Massachusetts Department of Public Safety  
Public Hearing on State Building Code 7<sup>th</sup> Edition  
November 6, 2007

**Submitted Public Comments**

# **AWC Guide to Wood Construction in High Wind Areas: 110 mph Wind Zone** **Massachusetts Checklist for Compliance (780 CMR 5301.2.1.1)<sup>1</sup>**

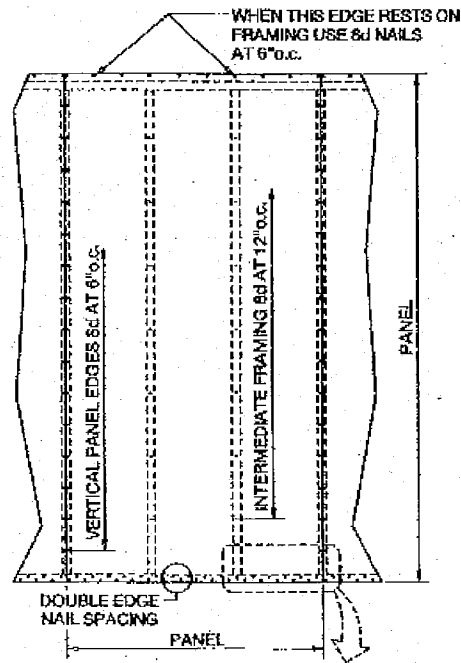
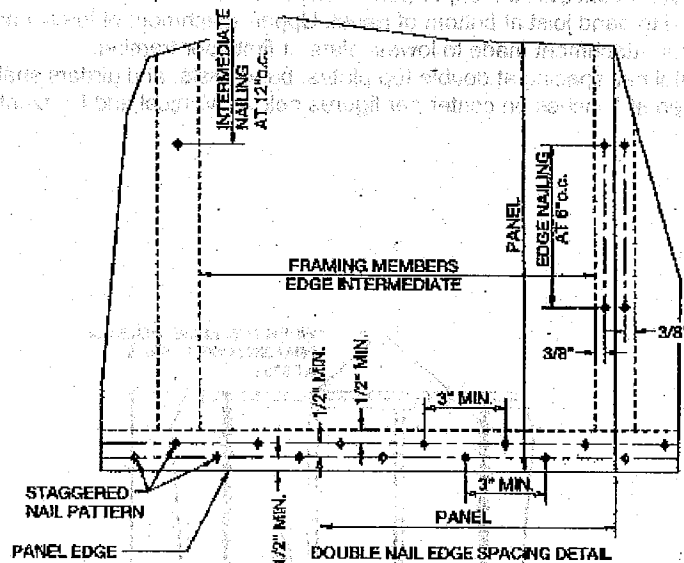
1. This checklist must shall be met in its entirety, excluding the specific exception noted in 2, to comply with the requirements of 780 CMR 5301.2.1.1 Item 1. If the checklist is met in its entirety then the following metal straps and hold downs are not required per the WFCM 110 mph Guide:
  - a. Steel Straps per Figure 5
  - b. 20 Gage Straps per Figure 11
  - c. Uplift Straps per Figure 14
  - d. All Straps per Figure 17
  - e. Corner Stud Hold Downs per Figure 18a and Figure 18b
2. Exception: Opening heights of up to 8 ft. shall be permitted when 5% is added to the percent full-height sheathing requirements shown in Tables 10 and 11.
3. The bottom sill plate in exterior walls shall be a minimum of two 2 in. (or single 4 in.) nominal thickness pressure treated #2-grade.
